Planning Officer's Report – LDCA DECEMBER 2021

APPLICATION	2021/87 – Change of Windows & Doors to Upvc
PERMISSION SOUGHT	Full Permission
REGISTERED	21 st October 2021
APPLICANT	Geoffrey Augustus
PARCEL	JT110010
LOCALITY	No 10 Barracks Square, Jamestown
ZONE	Intermediate
CONSERVATION AREA	Jamestown Historic Conservation Area
CURRENT USE	Existing House
PUBLICITY	The application was advertised as follows: <ul style="list-style-type: none">▪ Independent Newspaper on 22nd October 2021▪ A site notice displayed in accordance with Regulations.
EXPIRY	5 th November 2021
REPRESENTATIONS	None Received
DECISION ROUTE	Delegated / LDCA / EXCO

Diagrams 2 - 7: Plan Layout & Images Showing Existing Windows & Doors

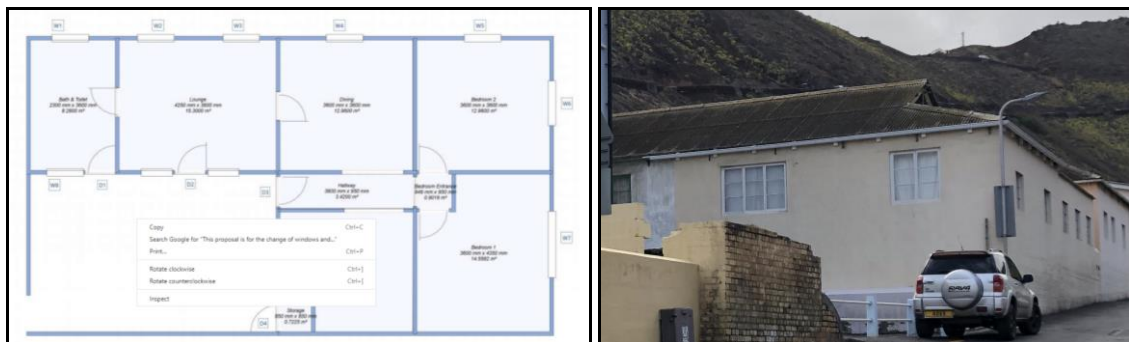
The existing building makes up the northwest corner of a number of houses that forms a square referred to as the Barracks. The existing building has a combination of galvanised and timber windows and doors with varying designs and operations that has evolved over the years with extensions and alterations that have taken place.

Diagrams 9 - 12: Proposed Window & Door Design

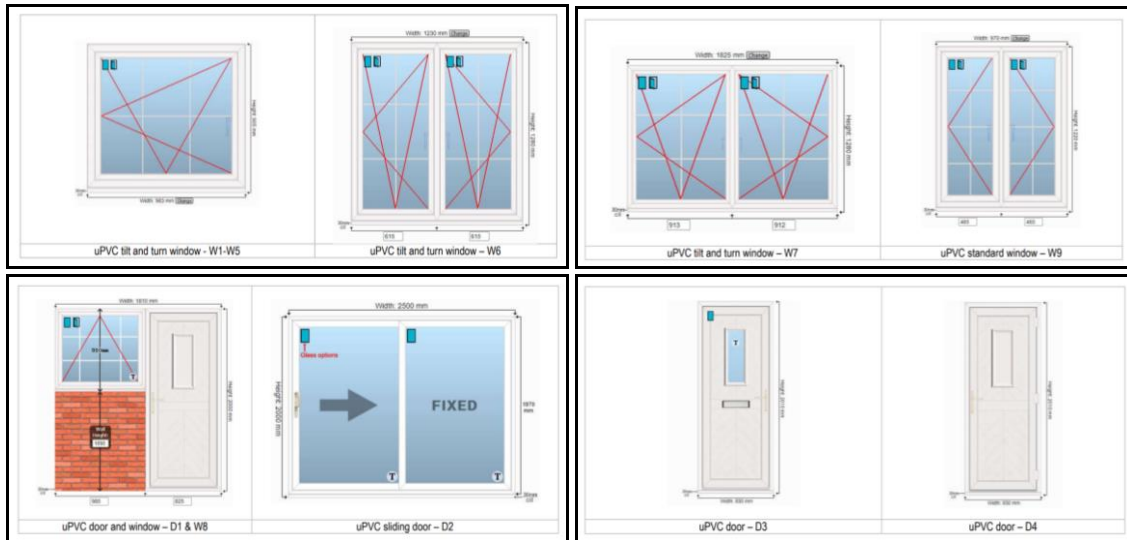
In assessing the impact of the development on the existing house, it is evident from the similar sizes and the tilt and turn design openings, that lighting and ventilation will not be affected into the main living areas of the house. The proposal, because of its opening designs will create a more functional and safer environment for the occupants from a cleaning perspective in relation to its direct contact with the street.

The appearance of the development will not be adversely impacted upon, as the windows proposed are of the same size and colour and carry some of the same small pane features as the existing.

Although the building is within the proposed conservation area, the proposal itself is not on a building of historical significance, therefore, the change from galvanised and timber to Upvc is considered acceptable in this area as can be seen with the window changes from galvanised to white Upvc coated windows made to Moores Flats in the image below. Moores Flats is directly adjacent to the proposed development.

Overall, this development will not adversely impact the appearance of the existing building nor the setting of the conservation area, and therefore can be supported.
